Memorandum

8 November 2021

City of Lee's Summit – Planning and Development Services Department
Plan Reviewer – Joe Frogge

Project: Plan Review Comments #1 / Revision #2.
FIT Muscle and Joint Clinic
413 NW Murray Road
Lee's Summit, MO 64081

MECHANICAL
FLOOR PLANS
M101

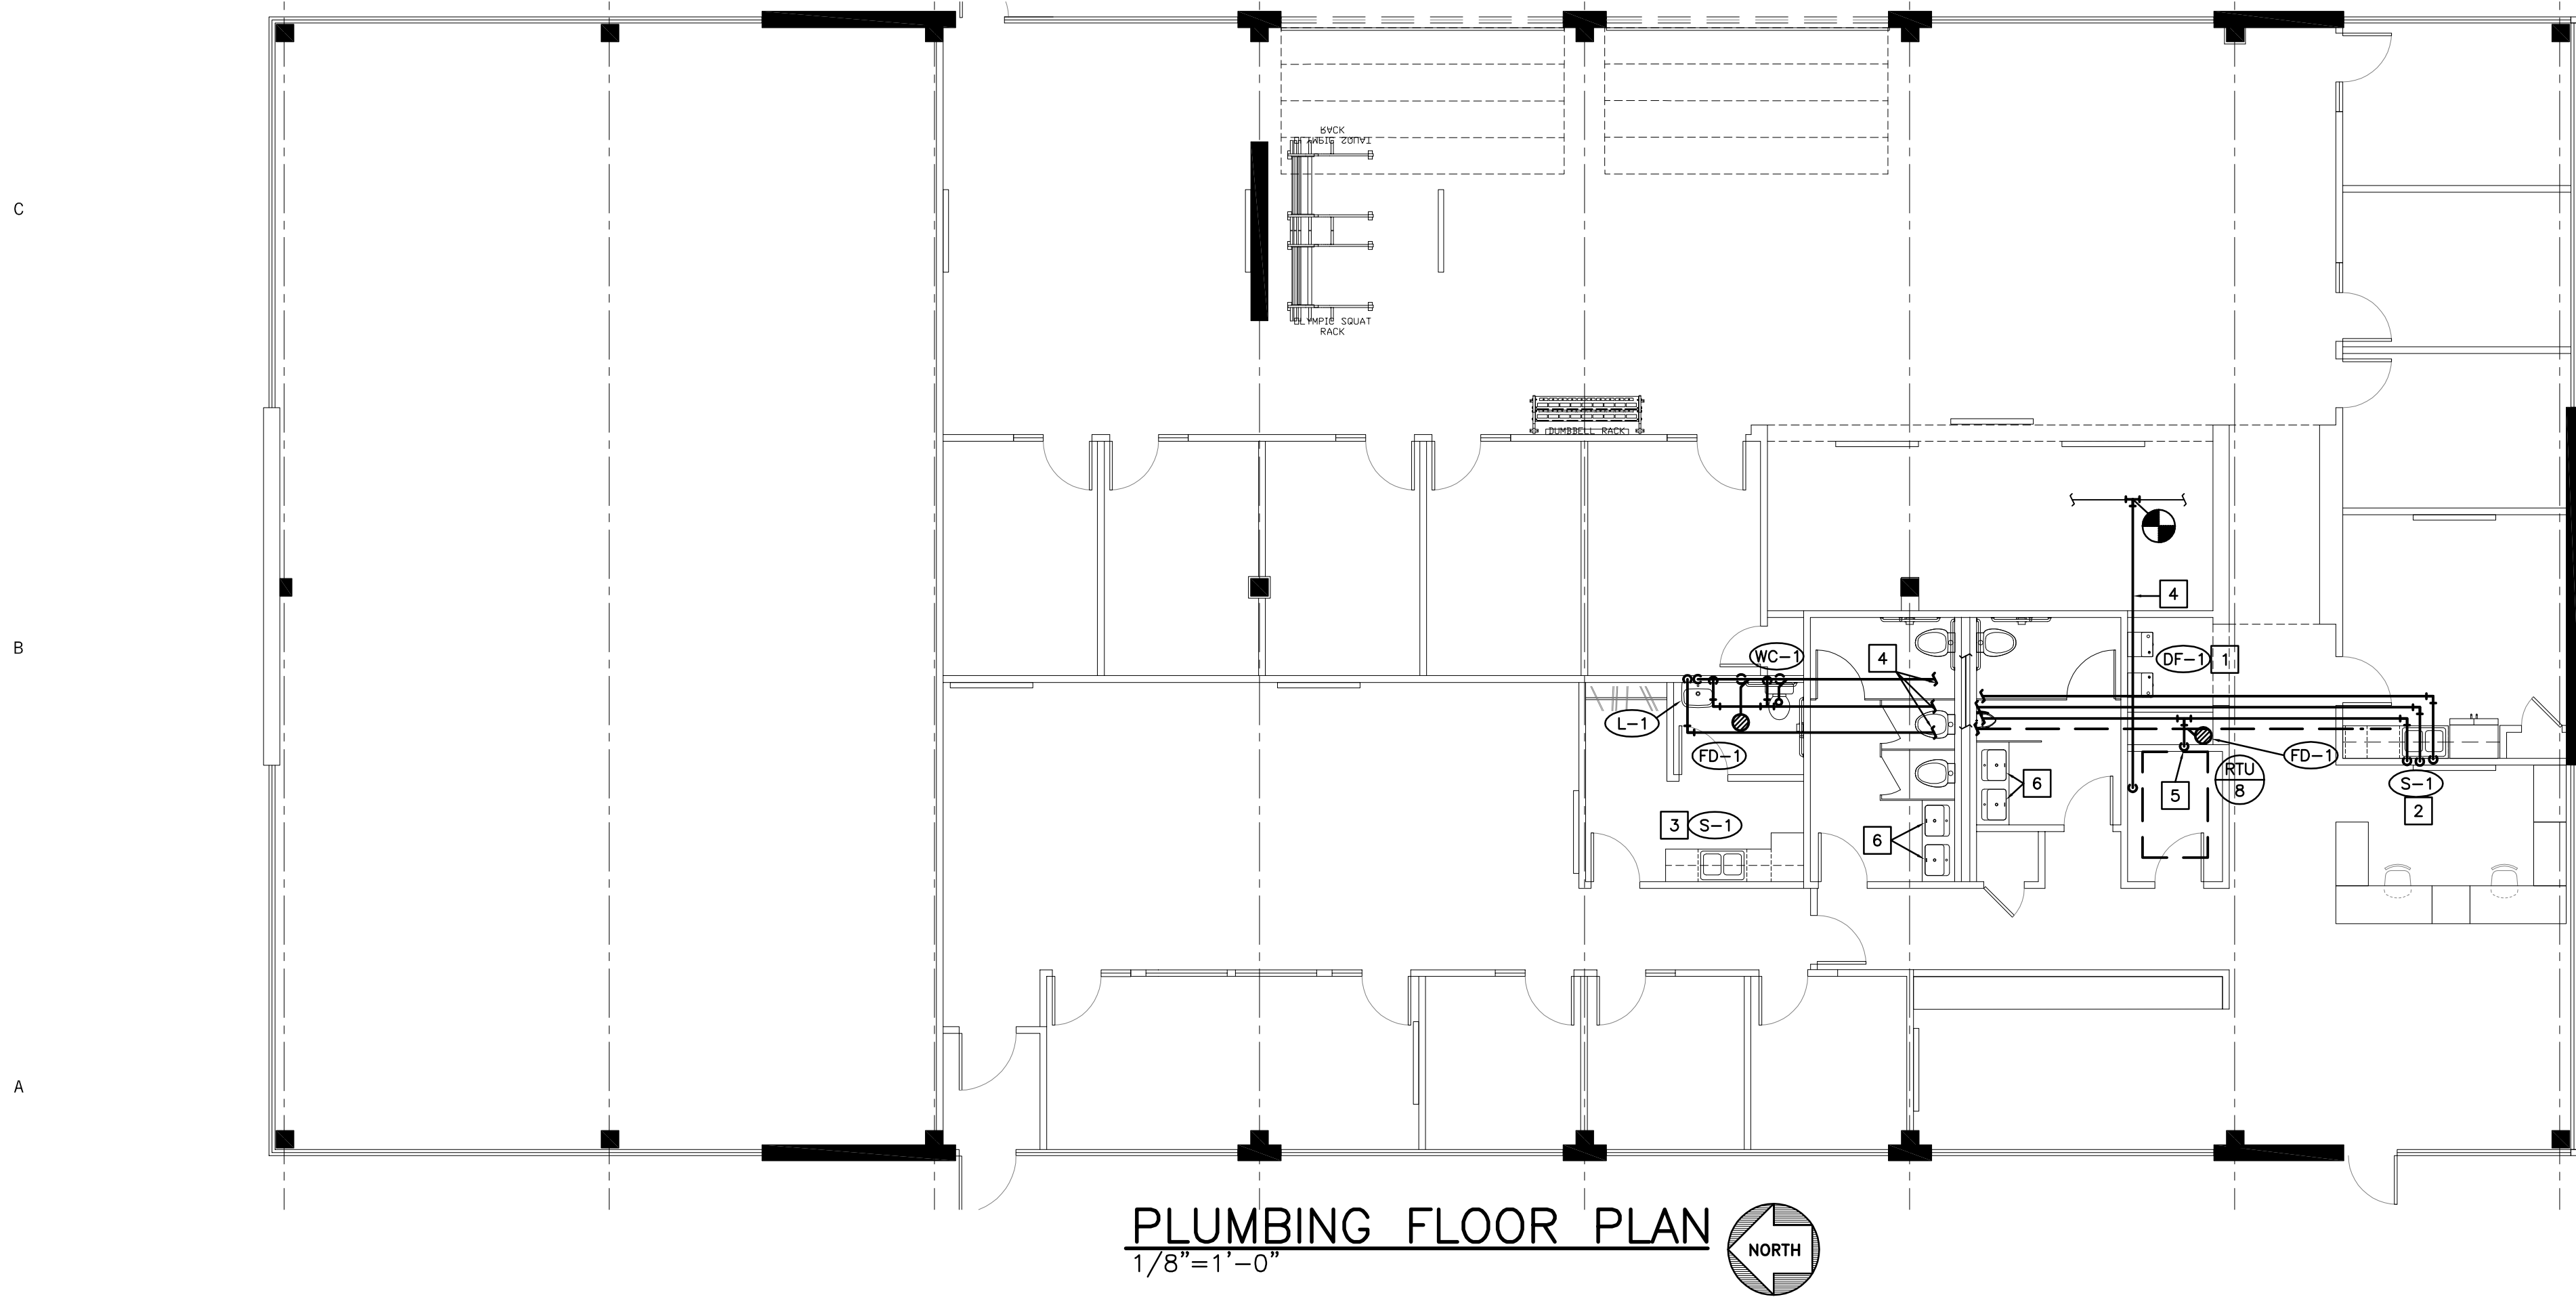
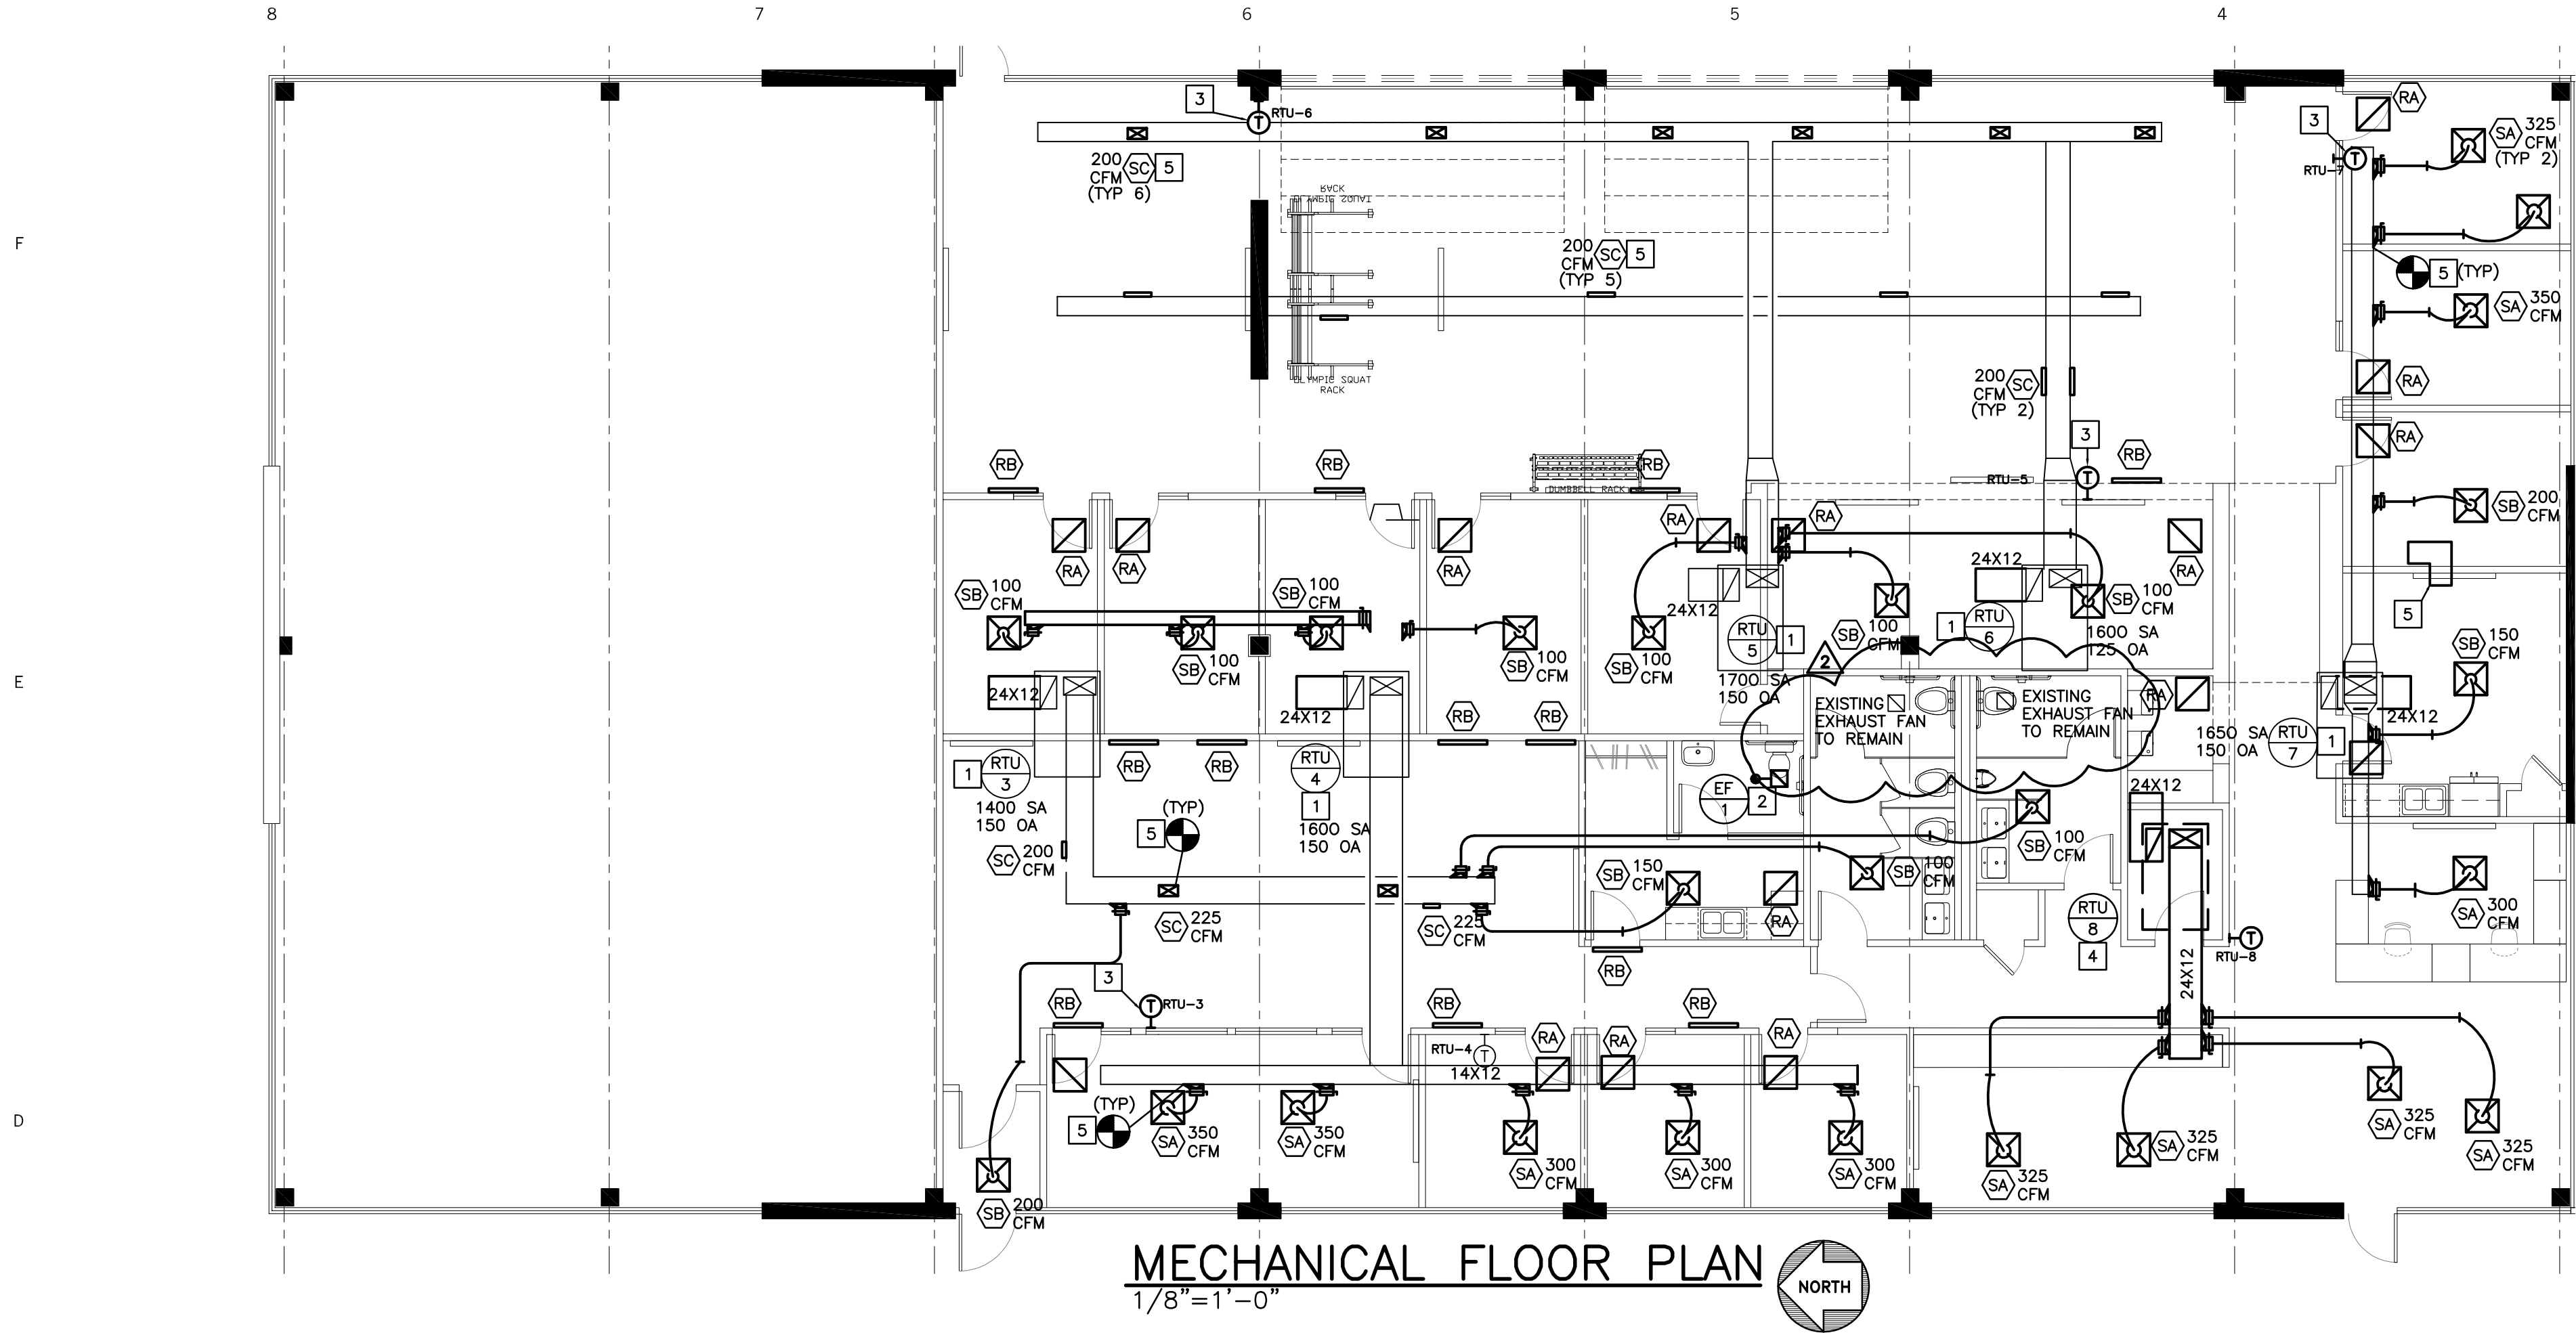
3. 2018 IMC 502.1 General. An exhaust system shall be provided, maintained and operated as specifically required by this section and for all occupied areas where machines, vats, tanks, furnaces, forges, salamanders and other appliances, equipment and processes in such areas produce or throw off dust or particles sufficiently light to float in the air, or emit heat, odors, fumes, spray, gas or smoke in such quantities so as to be irritating or injurious to health or safety.

Action required: Provide exhaust in all restrooms.

- 3) Response: Refer to M101 for note provided that existing exhaust fans shall be used in the public restrooms. EF-1 is already indicated in Restroom 208.
